Intersection ID: 19934	Main Street: W_ARROWWOOD_RD	Cross Street: WHITEWHITEHALL_EXECUTIVE_CENTER_DR	Location:	SW
ADA ID: 2B4AA6A700E7	Ramp Type: Combination1Diag	Initial Pass/Fail: Fail	Overall Compliance: No	Severity Score: 0

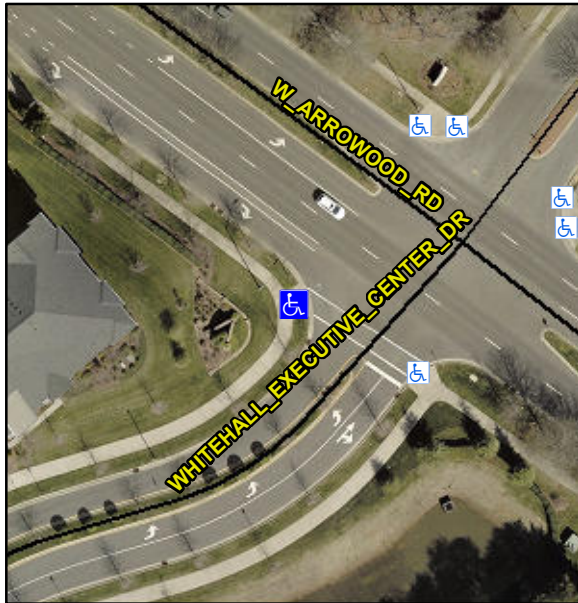
Not Found, R304.3.2

Compliance	Description	Data	Compliance	Description	Data
N/A	Ramp Length LT (in)	44.0	N/A	Ramp Length RT (in)	48.0
Yes	Ramp Width LT (in)	96.0	Yes	Ramp Width RT (in)	92.0
No	Ramp Slope LT (%)	8.5	Yes	Ramp Slope RT (%)	6.4
Yes	Ramp XSlope LT (%)	1.6	Yes	Ramp XSlope RT (%)	0.2
N/A	Ramp Length (in)	98.5	Yes	Ramp Slope (%)	6.3
Yes	Ramp Width (in)	48.0	Yes	Ramp XSlope (%)	0.7
N/A	Flare Type LT	N/A	N/A	Flare Type RT	N/A
N/A	Flare Slope LT (%)	N/A	N/A	Flare Slope RT (%)	N/A
N/A	Flare Traversable LT?	N/A	N/A	Flare Traversable RT?	N/A
N/A	Landing Length (in)	N/A	N/A	DWS Provided?	N/A
N/A	Landing Width (in)	N/A	N/A	DWS Contrast?	N/A
N/A	Landing Slope (%)	N/A	N/A	DWS Length (in)	N/A
N/A	Landing X Slope (%)	N/A	N/A	DWS Full Width?	N/A
N/A	Landing Curb? (Y/N)	N/A	N/A	DWS Offset (in)	N/A
N/A	Shared Landing?	N/A			
N/A	Gutter Ponding?	N/A	N/A	Gutter Slope (%)	N/A
N/A	Gutter Lip Ht (in)	N/A	N/A	Gutter X Slope (%)	N/A
N/A	Painted X Walk1?	Yes	N/A	Painted X Walk2?	No

Remove & Replace Curb Ramp With Two New Directional Ramps or Equivalent.
